Rezoning Transportation Analysis

Petition Number: 2021-089

General Location Identifier: 10503127

Revision Log:

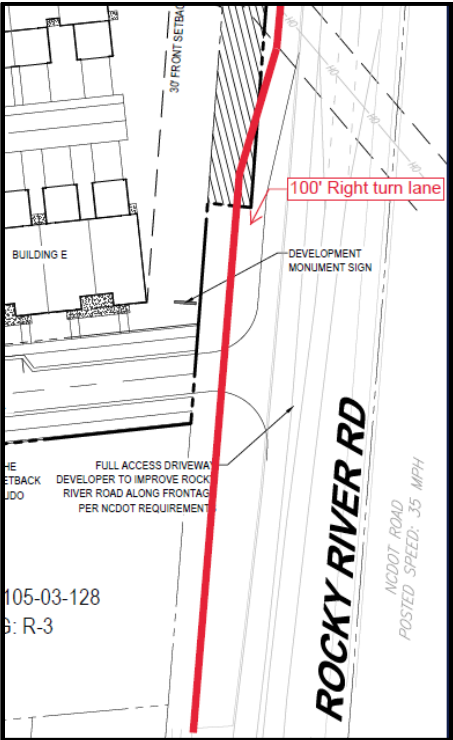
3. ~~Revise site plan and conditional note(s) to commit to dedicate 50' (minimum) right of way from the Rocky River Road centerline. The site plan shall label and dimension the right of way from the road centerline.~~

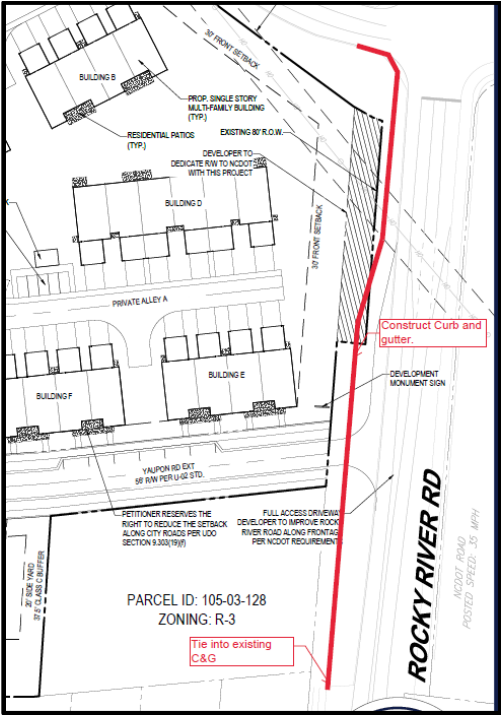
5. ~~Site plan and conditional note(s) revisions are needed to commit to providing a 100' right turn lane at the site's access on Rocky River Road per the NCDOT's standards. The proposed right turn lane should be dimensioned.~~

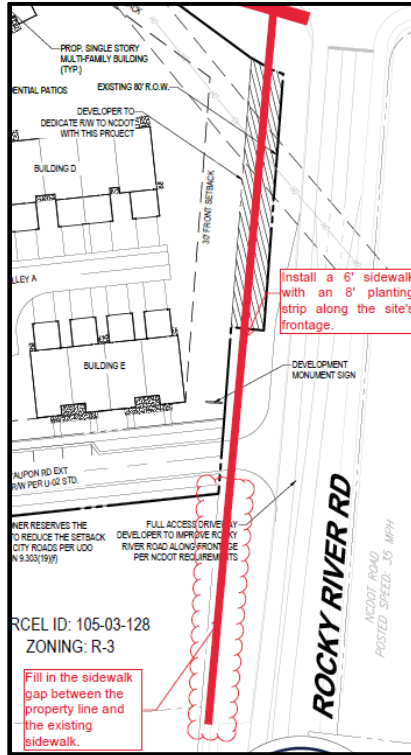
6. ~~Site plan and conditional note(s) revisions are needed to commit to construct bicycle facilities by installing the curb and gutter 35' from the Rocky River Road centerline per the Charlotte's BIKE Policy. The proposed curblines should match what has been set up west of the project.~~

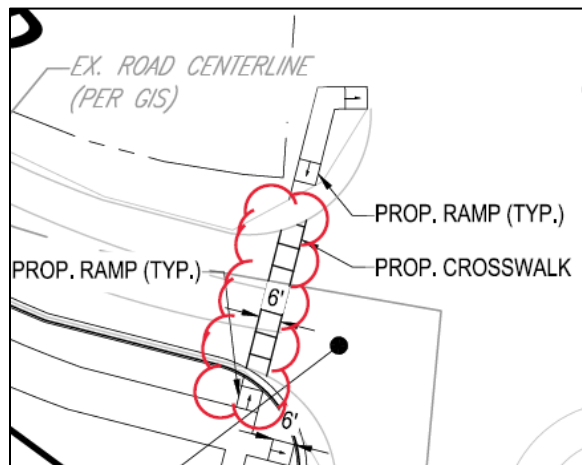
7. ~~Revise site plan and conditional note(s) to commit to construct an 8-foot planting strip, and 6-foot sidewalk on Rocky River Road per Chapter 20. Tie into the existing sidewalk west of the site to provide pedestrian connectivity and accessibility in accordance with PROWAG and the Charlotte Walks plan. The site plan shall label and dimension both items from the back of curb and gutter.~~

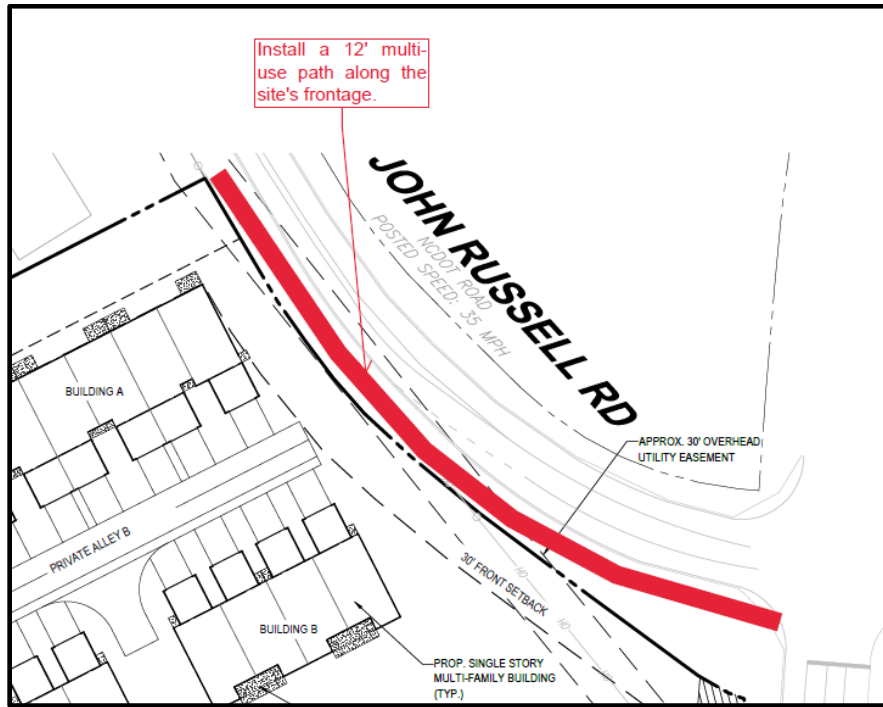
8. ~~Revise site plan and conditional note(s) to commit to construct accessible ramps and a crosswalk at the John Russel Road Intersection to provide accessibility in accordance with PROWAG and ADA. The site plan shall label and dimension all items.~~

Technical Clarification (10-18-21): The crosswalk width to be 10' wide unless otherwise specified.

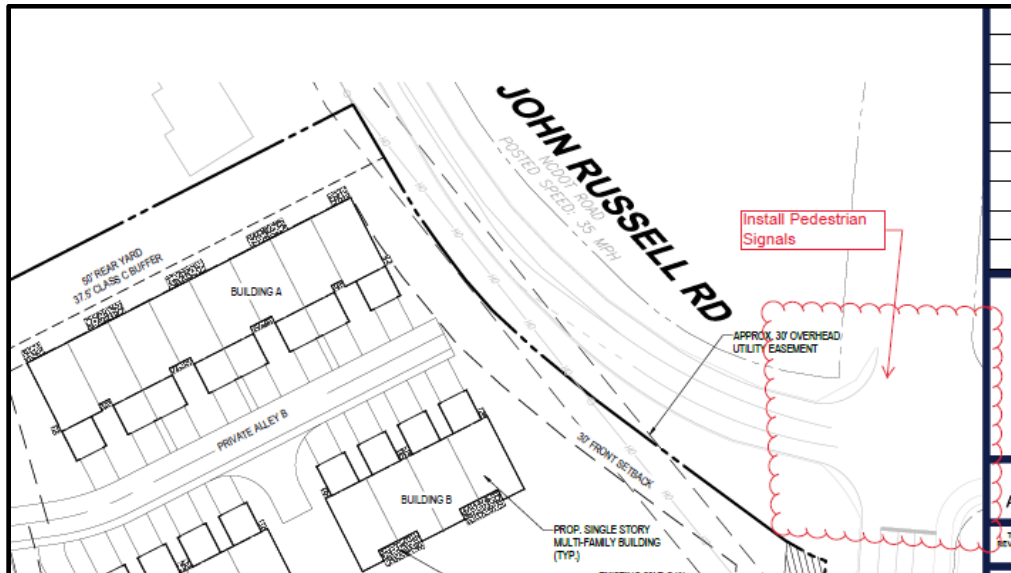
9. ~~Site plan and conditional note(s) revisions are needed to commit to construct pedestrian and bicycle facilities by installing a 12' multi-use path along the John Russel Road Frontage in accordance with the Charlotte BIKES Policy.~~

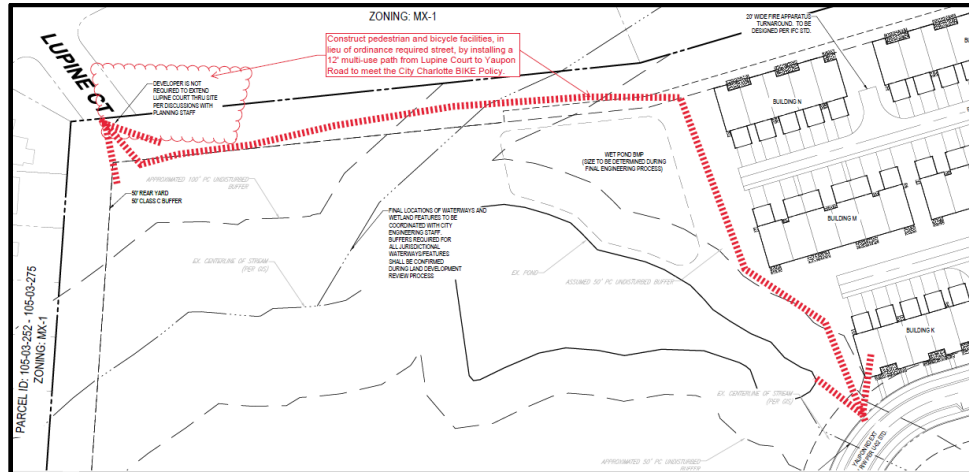
10. ~~Site plan and conditional note(s) revisions are needed to commit to upgrade the pedestrian signal equipment at the John Russel Road and Rocky River Road intersection to meet PROWAG and ADA standards. The pedestrian signal upgrade will include APS installation and the relocation of pedestrian signals off existing wood pole~~
